Transportation Impact Study Trieste Residential Development

Phoenixville Borough, Chester County, PA

Prepared for
Phoenixville Borough

January 18, 2022
McMahon Project Number 816819.21

FIGURE 2

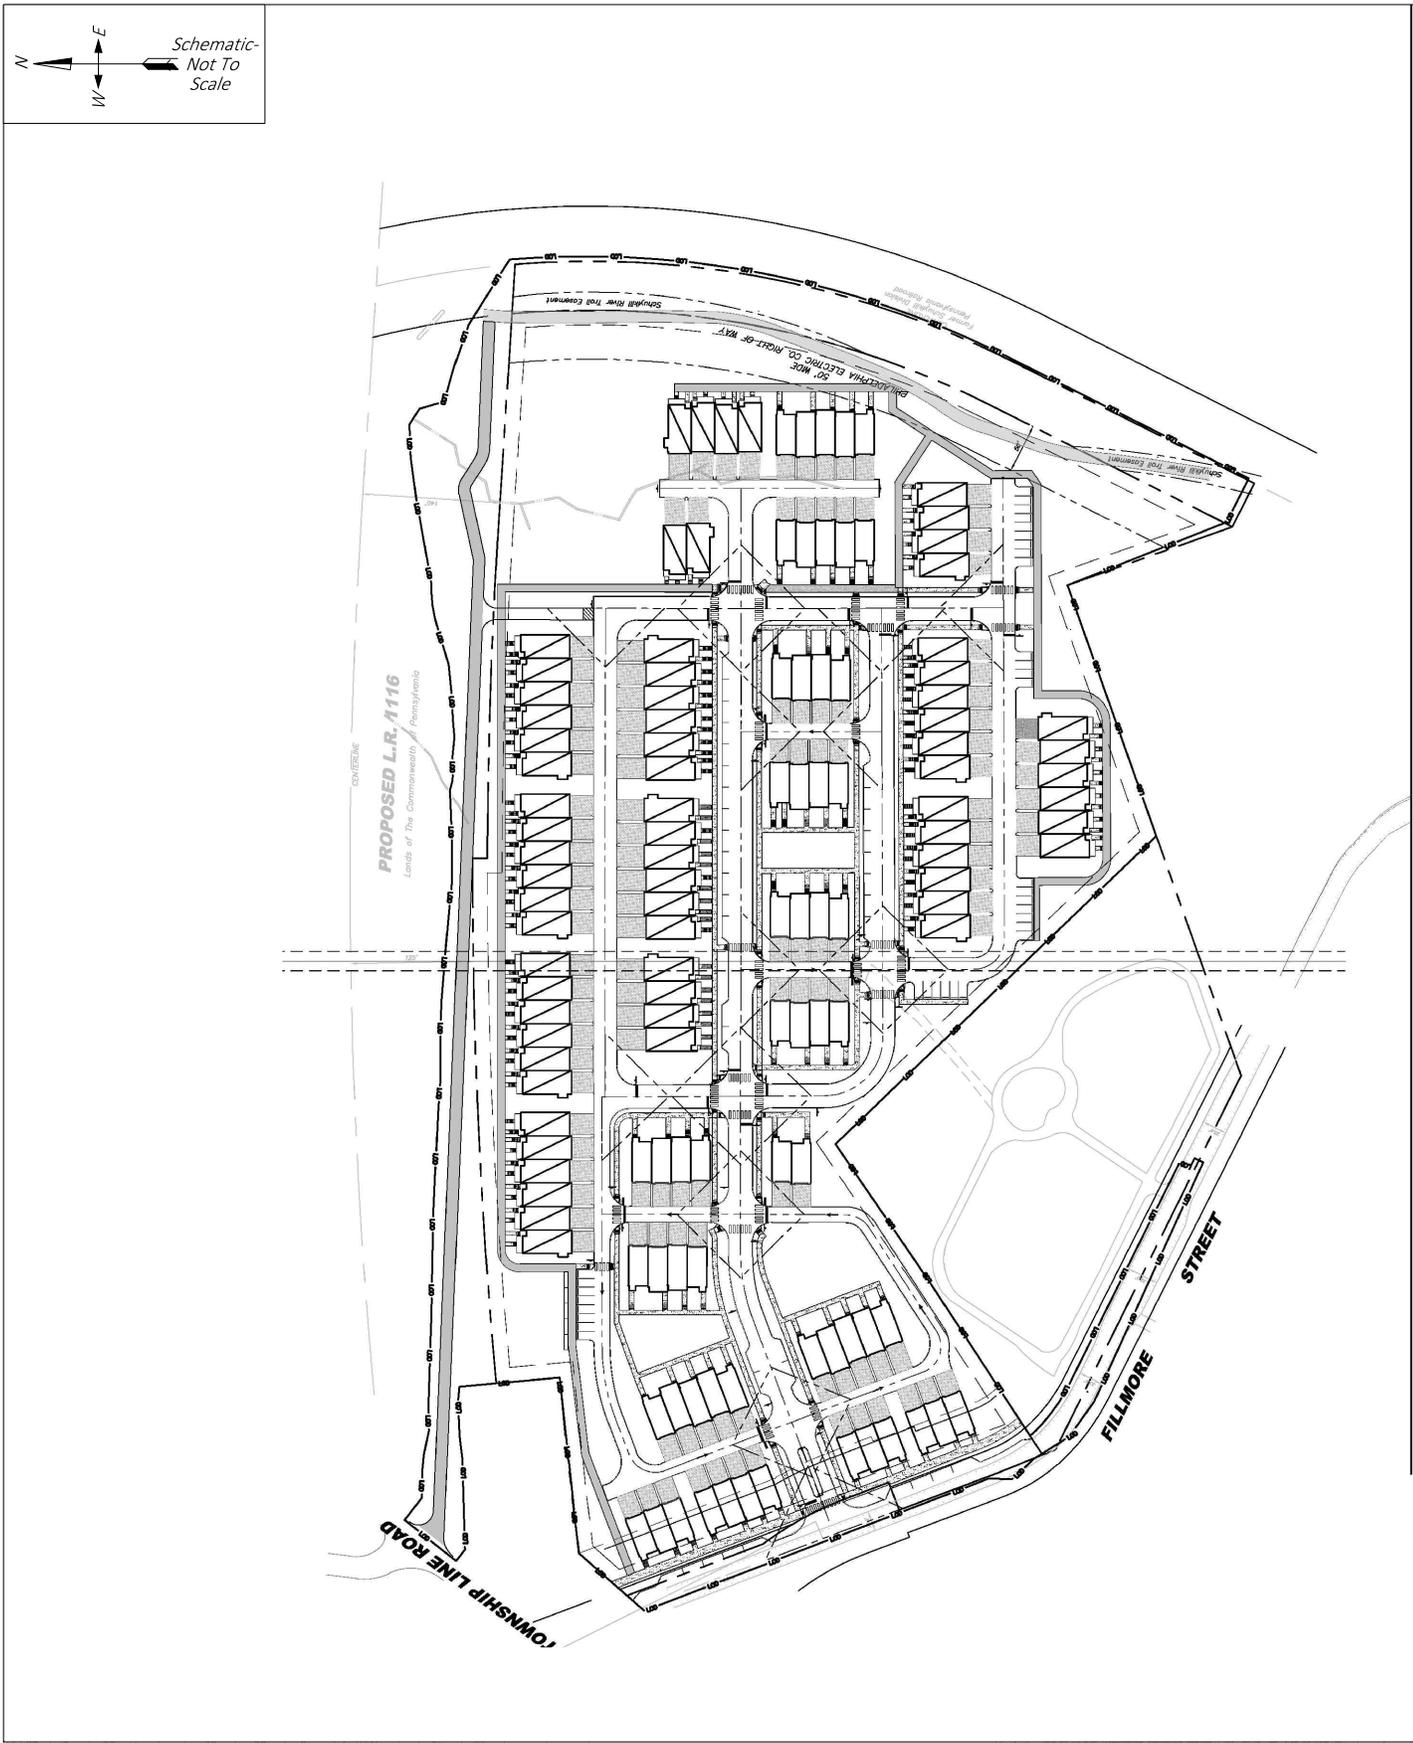
- Residential moving trucks
- Based on the fire truck turning templates provided by the applicant, some maneuvers require traversing over curbs, landscaped medians, or into residential driveways which may conflict with parked vehicles. Revise the truck turning templates or site design as needed to avoid these conflicts.

- Based on the garbage truck turning templates provided by the applicant, some maneuvers require traversing over curbs, which is not acceptable. Additionally, the turning templates show multiple start and end points rather than a continuous route which the trucks would follow as they service the development. Coordinate with the Phoenixville Sanitation Department regarding preferred routing through the development and revise the turning templates to simulate this route.

- The number of stop signs within the internal roadway network is excessive. The main roadway, designated as Road A, entering the development has stop signs along Road A spaced approximately every 100 feet. The close spacing and frequency of stop signs may lead to non-compliance, creating unnecessary vehicle-pedestrian and vehicle-vehicle conflicts as some drivers may not come to a complete stop. Consider other measures such as raised intersections/crosswalks or other traffic calming elements to reduce the frequency for stop signs.

- Some of the sight triangles along the internal roadways traverse residential driveways which would be blocked by parked vehicles.
- Resurface Fillmore Street from Township Line Road to the southern property line to address pavement deficiencies or as determined necessary by the Township Engineer and/or Public Works Department.

- If cluster mailboxes are to be used, the site plan should show the location of the mailboxes and provide parking for mail delivery vehicles adjacent to the mailboxes.

- The pedestrian facilities along Alley 4 should provide a continuous connection to both the east and west (a gap currently exists on the proposed plan).
